COMMENT RESPONSE SHEET

NAME OF THE DOCUMENT : COMMENT RESPONSE SHEET FOR P & IDs FOR HVWS SYSTEM (DOC NO: PY-DP-1-M087-8315-02- REV-00)

NAME OF THE PROJECT : 1x250 MW Rourkela TPP

DOCUMENT NUMBER : PESD/15/ROURKELA/FPS/579 Dated 27.03.2017

HVW SPRAY SYSTEM FOR TRANSFORMERS/ EQUIPMENTS
(TYPICAL ARRANGEMENT OF DELUGE VALVE ASSEMBLY)

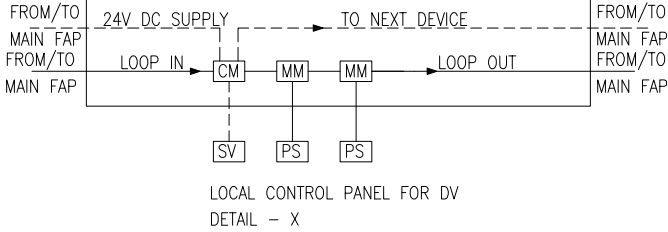
sl no	M/s Mecon / Customer Comments	BHEL Replies
1	DPG shall be provided across strainer	As per standard practice ,the DPG is not being provided across the Y-strainer at upstream of deluge valve. However, as per scheme of HVWS SYSTEM (MEC/G24F/11/14/HVWS/01-REV-00) attched as part of Tender Specification, no DPG has been envisaged across the Y-strainer. Hence the same is not considered in Y-strainer of Spray system.
2	Please provide the tag number agaianst each instrument.	This is a typical schematic for the HVWS system and the same shall be indiacted in the individual layout of respective protected equipments. All the deatils shall be indiacted in the respective drawing. Hence tag number against each instrument has not been provided in this document.
3	Please provide the write up for operational / control philosophy	The write up for the system operation is indiacted in the schematic of the HVWS system. For the control philosophy of HVWS system, please refer the clause number 3.6.a and page number 12 of 26 of the design basis (PY-SZ-4-M087-8315-01).

4	Please provide gate valve at the upstream of the deluge valve.	The butter fly valve has been provided at the upstream of the deluge valve for isolation purpose, as per scheme of HVWS SYSTEM (MEC/G24F/11/14/HVWS/01-REV-00) attched as part of Tender Specification.
5	Detectors shall be provided in a ring.	Technically ring formation is not required for the detector line . If Customer / Mecon insist for the same , the same shall be provided in the next revision of the schematic diagram of HVWS system.
6	Please provide HVWS system for LDO/HFO tank.	No additional fuel oil storage tank (HFO/LDO) has been envisaged as per agreed contract document. However Manual operated MVWS system has been provided for the existing HFO /LDO tank as per technical specification (section -VI, Vol-1, Bid doc No: CC & M-C-347-211, chapter 4, page 81 of 272). The same is covered in P & ID diagram for MVW spray system (document number : PY-DP-1-M087-8315-03).
